Comal County Environmental Health

Permit of Authorization to Construct an On-Site Sewage Facility Permit Valid For One Year From Date Issued

Permit Number: 117183
Issued This Date: 03/08/2024
This permit is hereby given to: Jennifer Zarcone & Michael Fassler

*** COMAL COUNTY OFFICE OF ENVIRONMENTAL HEALTH
APPLICATION FOR PERMIT FOR AUTHORIZATION TO CONSTRUCT AN
ON-SITE SEWAGE FACILITY AND LICENSE TO OPERATE

site map
Aerobic with Spray Distribution system
Jennifer Zarcone and Michael Fassler
Lot 128R, Unit 2
Cordova Bend at Canyon Lake
1111 Aguayo
Canyon Lake, Texas 78133
Comal County

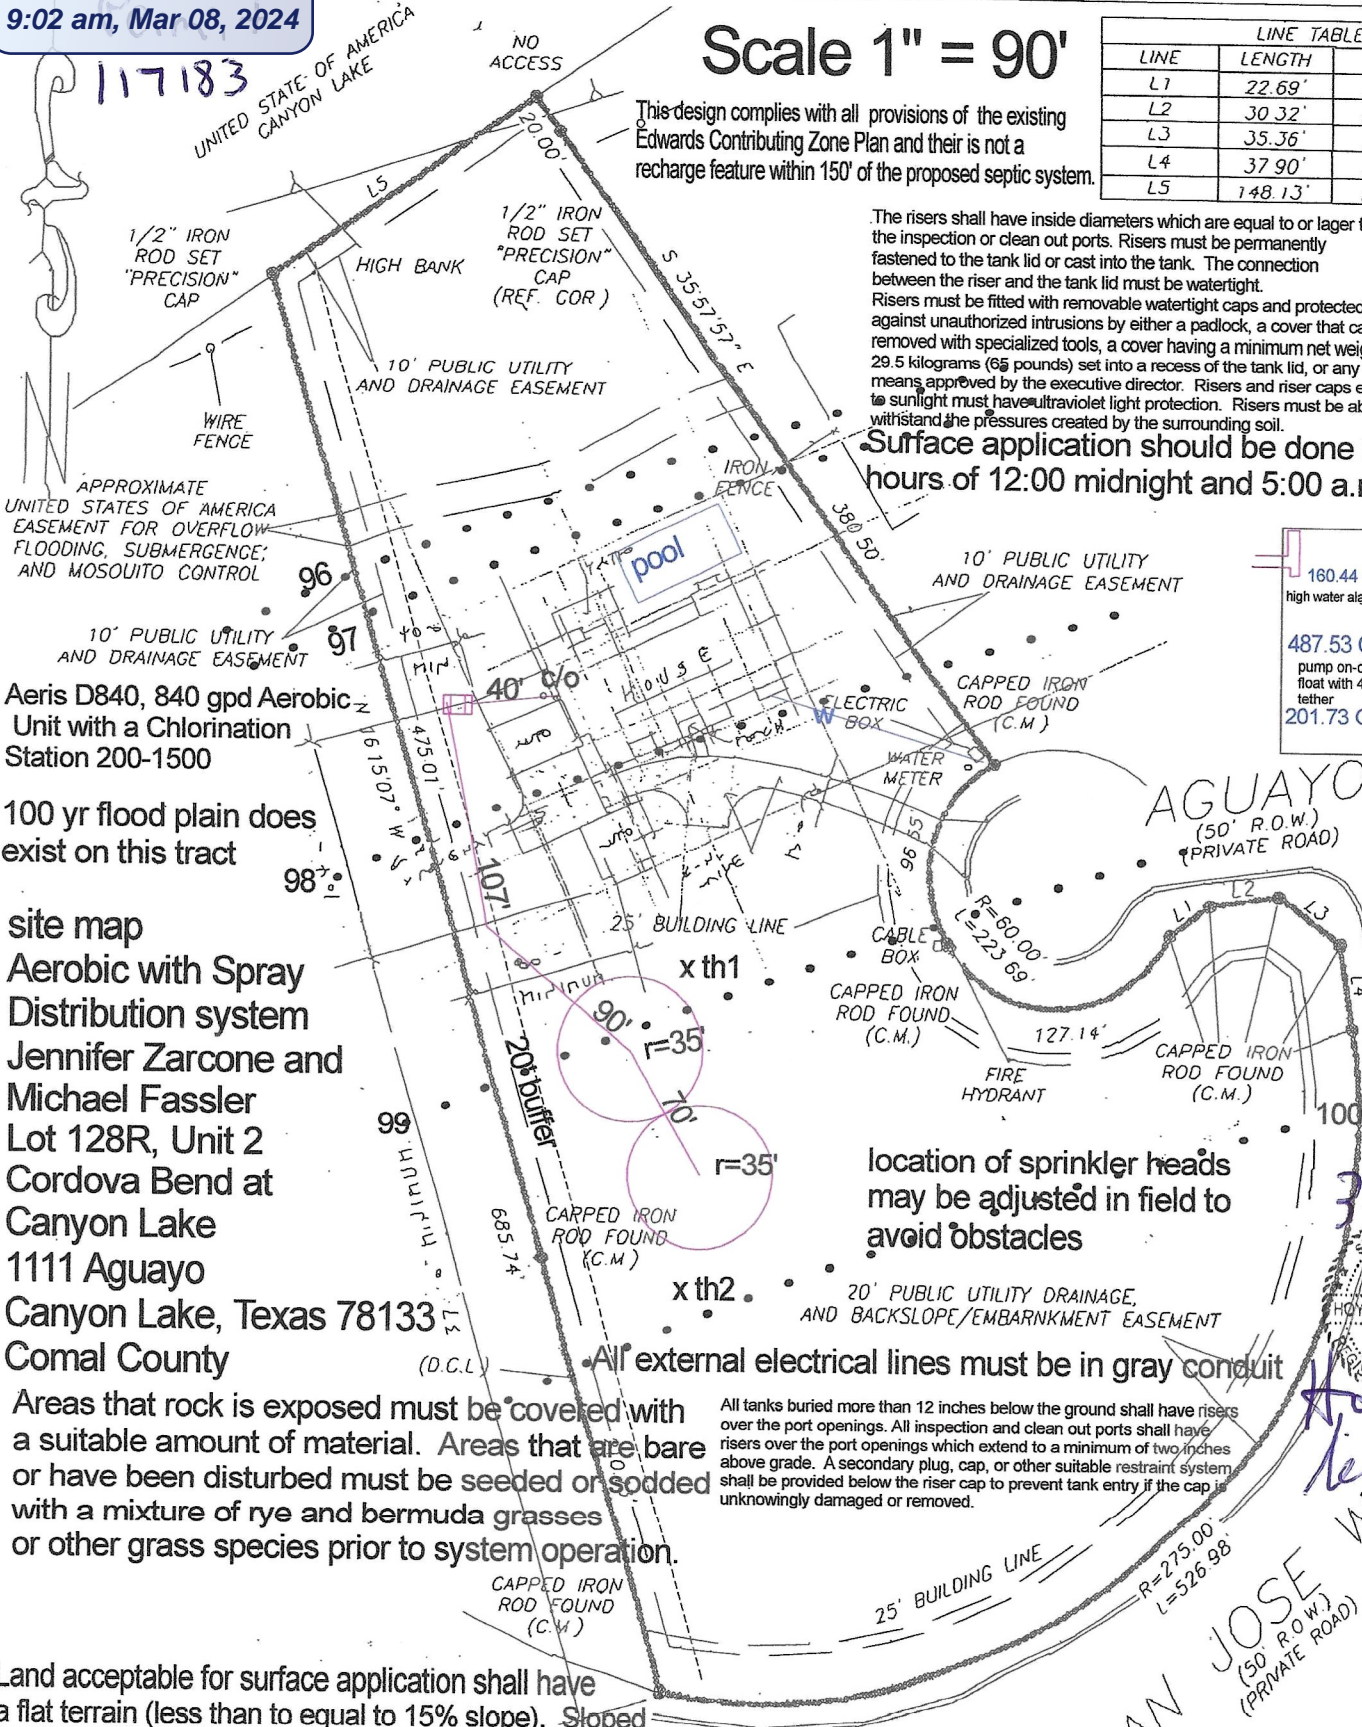
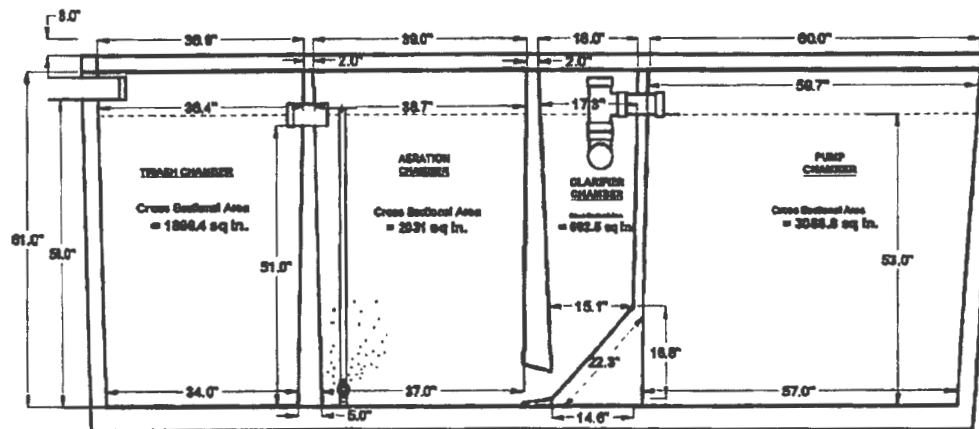
100 yr flood plain does exist on this tract

The deed and design are for Lot 128R. Is this correct? If so, revise the permit application accordingly and resubmit. Also it appears the site evaluator needs to correct the lot number indicated on the Site Evaluation Report Information form.

100 yr flood plain does not exist on this tract
